ADDENDUM 4

Miami Lakes Library Branch

EXTERIOR IMPROVEMENTS AND COMPREHENSIVE INTERIOR RENOVATIONS

C23-MDPLS-02-ESP

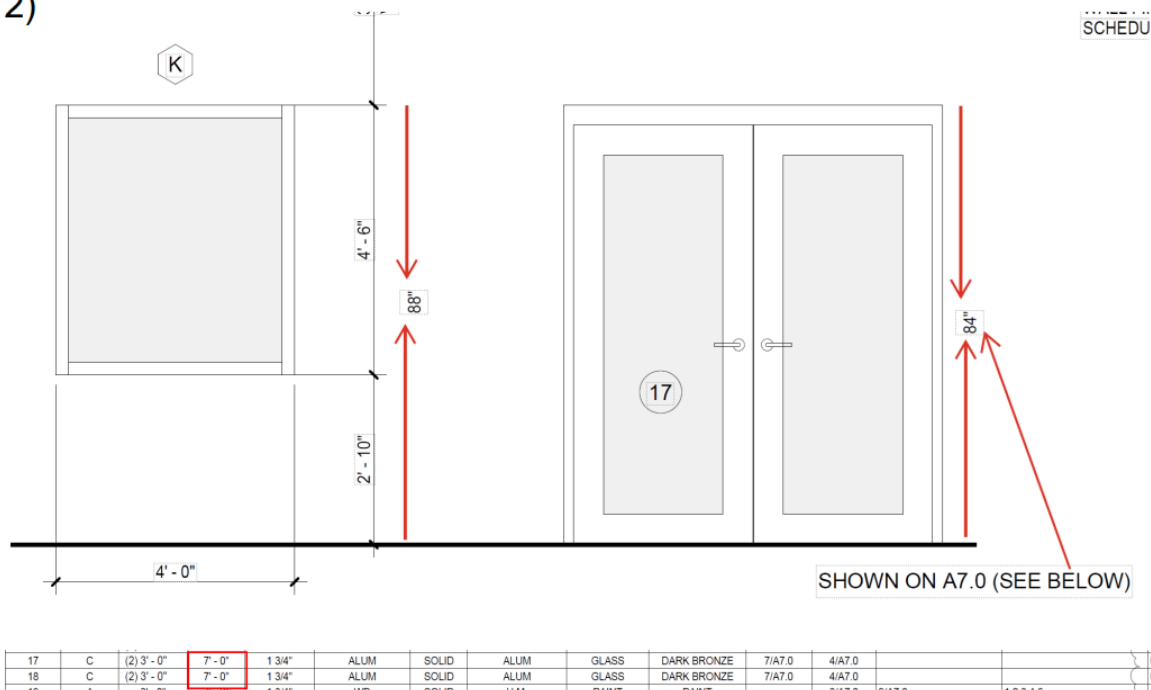
Q.13 Could you include in the RFI clarification regarding the dimensions of the automatic doors (#1 and #2)? The dimensions shown on Sheet A7.0 are not correct. Door #1 is adjacent to Storefront Mark A, which has a height of 96". Also, each automatic door consists of 4 panels, but the width shown on Sheet A7.0 corresponds to only 2 panels. Could you include in the RFI clarification regarding the height of Doors 17 and 18? These doors are aligned with the elevation where Mark K will be installed. On sheet A6.0, the height calculation adds up to 88", but the door schedule indicates a height of 84". Please confirm which height is correct.

A13. *The masonry opening is 8'-0" to bottom of beam, which corresponds with Glazing Elevation for Storefront Mark 'A'. The automatic door assembly shall also correspond to this masonry opening. Per 4/A7.1, the controller shroud is approximately 8" deep, which would result in a door height of 7'-4", as indicated on the door schedule.*

The door panels within the assembly shall be two 3'-0" leaves and indicated on the door schedule. The total assembly shall include 4 panels; two fixed and two sliding doors.

The doors panels within the assembly shall be 7'-0" high with the frame. The total height of the assembly will be approximately 86" high. Windows Mark 'K' shall be provided as dimensioned, 4'-0" wide x 4'-6" high; however, the top of the window shall align with the top of the door at 86", not 88".

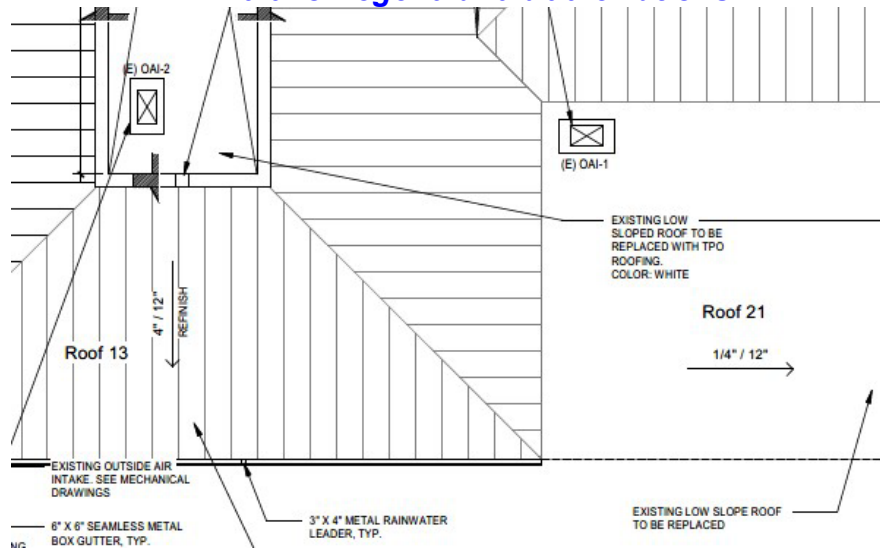
Q15. Division 23 of the Specs were not provided with the Bid documents for this project. Kindly confirm if there is a list of approved alternate manufacturers that can be considered for the new equipment specified in the schedules shown on drawings M5.0 & M5.1. **Please provide the information at the earliest convenience to request prices from suppliers.**

A15. *The project does not have Specs. Please refer to M-0.0*

All specifications are included in the drawings. The new equipment specified was verified by the MEP Engineer to fit within the existing enclosure and work with the existing equipment scheduled to remain. Alternate/substitutions of products will be reviewed after NTP and not during the bidding process; however, per Division 1, 016000 Products, there is a specific approval process, and the Contractor will be responsible for all changes, permitting and costs due to the alternate/substitution. MDPLS reserves the right to request credit.

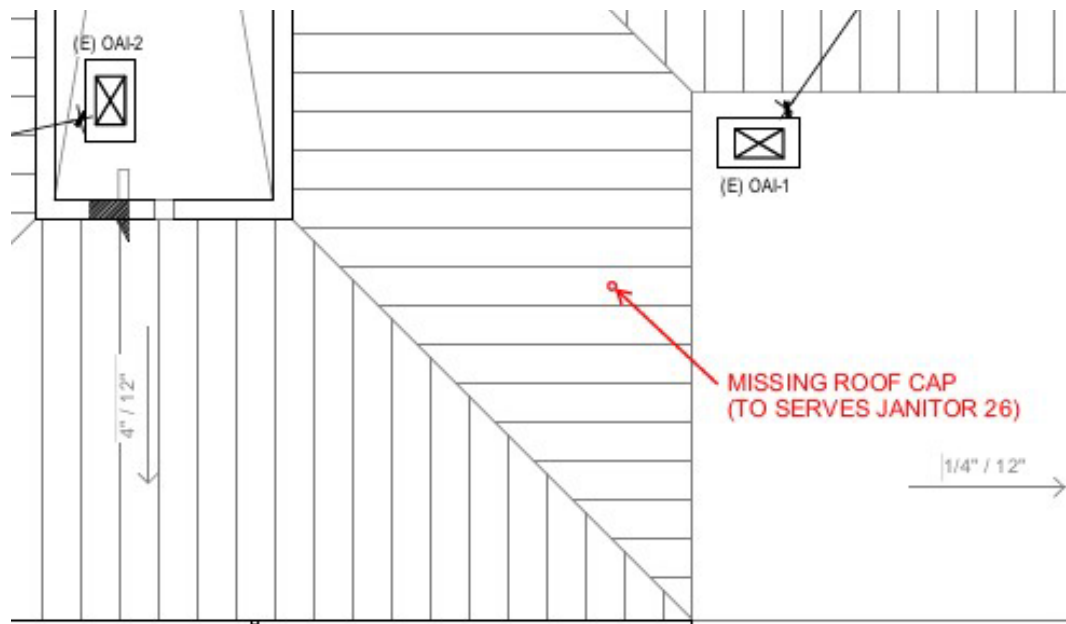
Q17. Janitor area 26 (M3.0) shows a (N) Ceiling EF with an extraction duct to be connected to a roof cap on the roof. This roof cap is not shown on plan M3.1 (see below).

A17. General Contractor is responsible for providing all roof caps.

NEW WORK
3 Enlarged Chiller Yard Floor Plan - HVAC
Scale: 1/4" = 1'-0"

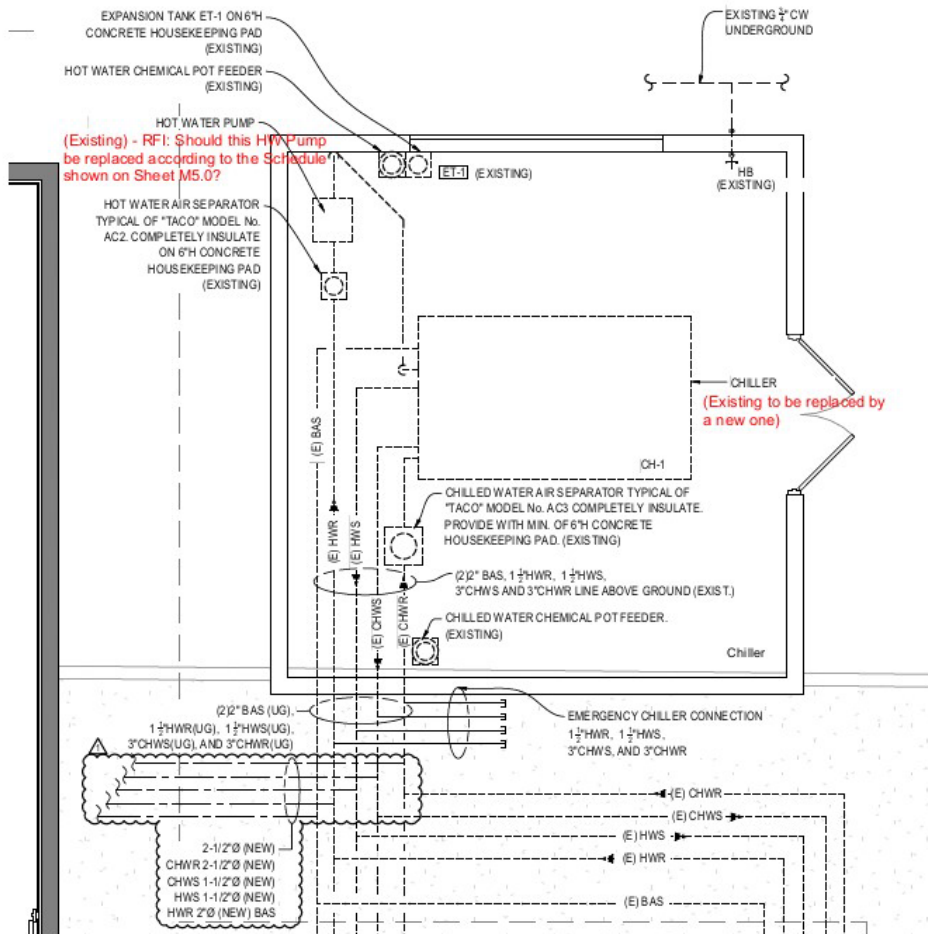
Q24. Drawing M5.0 shows a schedule for HW pump (HWP-1). Detail 3 – Enlarged Chiller Yard Floor Plan on Drawing M4.0 shows the location of a HW Pump (see below) but does not indicate whether this pump is an existing pump to be replaced according to the schedule on Drawing M5.0. *Please confirm whether, along with the scope of replacing the existing Air-Cooled Chiller, we should include the replacement of the HW pump with its associated triple duty valve and strainer.*

A24. *The HWP-1 pump is existing to be replaced with a new one. Provide a 45 GPM pump.*
